## 17 Avenue S.E. Corridor Study Options Development Workshop October 2015

### PROJECT OVERVIEW

Feedback about preliminary options

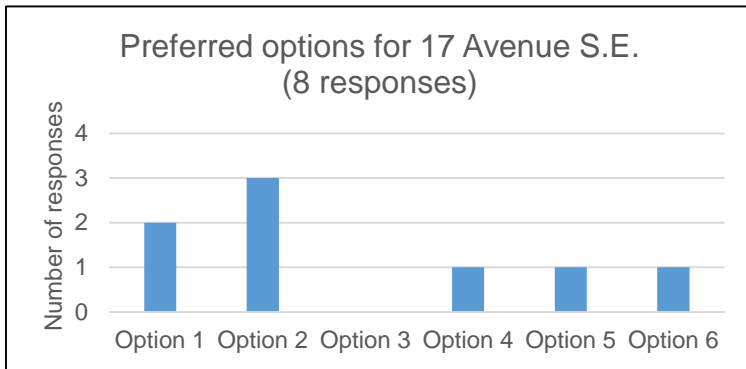
Respondents that preferred Option 1 said they liked that the public realm/green space is maintained.  
 Respondents that preferred Option 2 said they liked that cyclists are separated from traffic.

Verbatim comments
Balances travel needs, parking, and active modes transportation. Cyclists on street is preferred to pathway connection at full build out.
Keeps pedestrians and cyclists away from traffic. Also, the flow of traffic would be consistent.
Simple yet effective with separation between vehicle and pedestrian.
Bike/pedestrian separation as they travel at different speeds. Mass transit takes up less space & poses no risk for maintaining green space.
Varying space for public realm and buildings, they are not all set at the property line making a more interesting streetscape.
Uses parking, cycling and green space as a buffer, vehicles don't cross bike lane to park.
I think it best suits the area.

Verbatim comments
Ensure buffer between parked cars and bike lane is wide enough (removes car door opening hazard for cyclists).
Nothing.
Varying size of walk width with utilizing some of the greenspaces for resting, sitting and lounging areas.
Vary Streetscape so buildings are not lining the street but have opportunities for angle parking and gathering spots within the public realm.
Move the green space up to the property line.
Vary width and orientation of green space based on location and storm water management.
